GREATER GEELONG PLANNING SCHEME

Proposed C433ggee

SCHEDULE 56 TO CLAUSE 43.02 DESIGN AND DEVELOPMENT OVERLAY

GORDON AVENUE PRECINCT

Figure 2. Future Park Interface

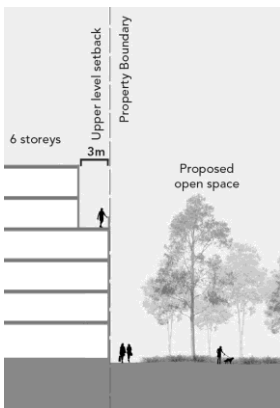
[Editing Note: ground floor building setback 2m from proposed open space]

Commented [COGG12]: Response to AR rec 37.

Figure 6. Preferred side separation for buildings ~~up to 8 storeys~~ built to boundary

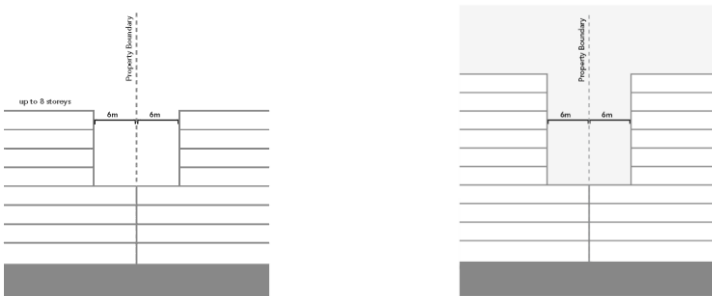
[Editing Note: Diagram above left replaced with diagram above right showing additional two more levels and removing the text “up to 10 storeys.”]

Commented [COGG14]: Response to JG rec 17 and AR rec 38.

Where a ~~building site abuts another site subject to this schedule, is to be built to a common boundary~~, the minimum side setbacks at Figures 6 ~~and 7~~ applies.
